**Before the  
ENVIRONMENTAL PROTECTION AGENCY  
Washington, DC 20004  
February 3rd, 2012**

2017 and Later Model Year Light-Duty  
Vehicle Greenhouse Gas Emissions and  
Corporate Average Fuel Economy Standards

Docket ID No. EPA-HQ-OAR-2010-0799

**COMMENTS OF SAM BATKINS AND CATRINA RORKE**

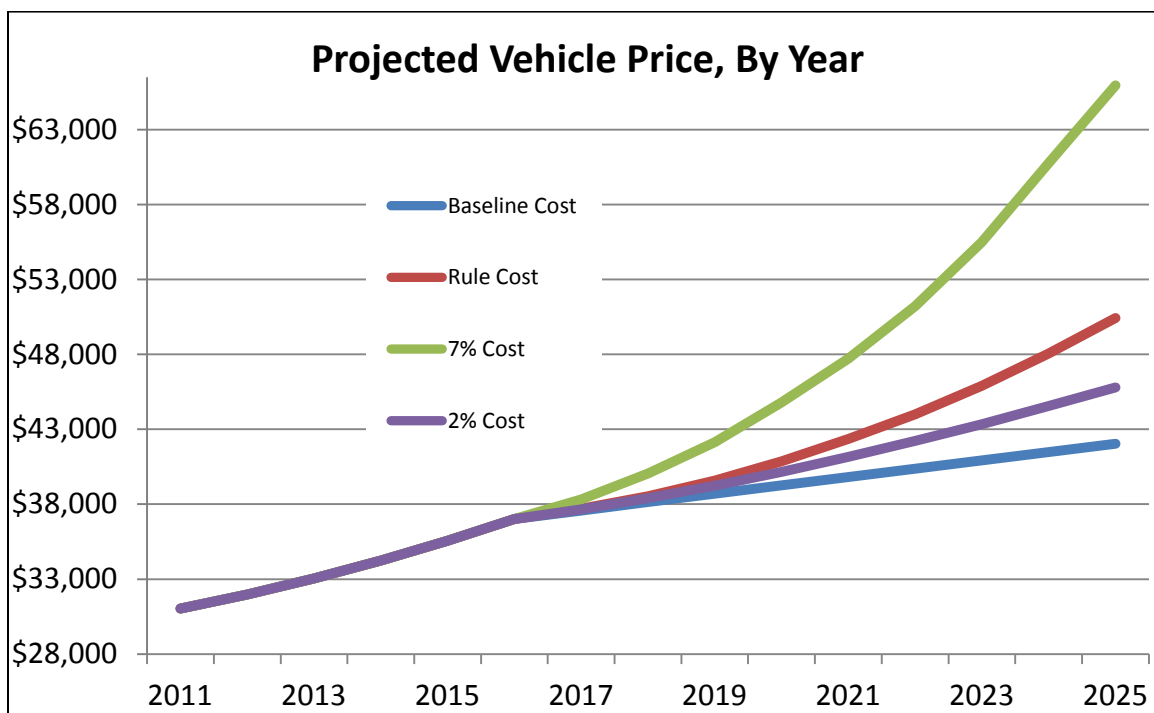
To estimate the potential impact on sales, we used a baseline of available sales data from 2000 to 2007. This data yields an average annual vehicle price increase of \$557.14. Projecting this average price increase to 2025 in current dollars, we established an average vehicle baseline price of \$38,828.57 at the end of the regulated period. Including cost considerations from the current CAFE rules (2012-2016), the average vehicle baseline cost increases to \$42,037.57.

To calculate the impact of the proposed CAFE rules on vehicle prices, we used the Regulatory Impact Analysis (RIA) "Table 5c: Average Incremental Technology Costs or Fines Per Vehicle, Combined." The preferred alternative described in the RIA will raise vehicle prices \$8,394 above baseline over the compliance window, or 19.9 percent.

This is an alarming figure, if we presume the "broad consensus" on demand elasticity as -1.0 is correct. A demand elasticity even half that would still yield a 9.9 percent decrease in sales. A 19.9 percent decrease in sales as a result of the proposed rule would cost billions of dollars, and countless jobs.

However, given the complexity of accurately projecting employment and economic impacts to 2025, we also assessed two alternative figures for CAFE-related efficiency increases taken from the RIA to illustrate a range of scenarios that the auto industry might face under such a policy (see figure, below). For example, the 2 percent alternative would still increase prices – and depress vehicle sales – during the compliance period by 8.9 percent. Likewise, the 7 percent alternative could hike vehicle prices by an impressive 56.9 percent.
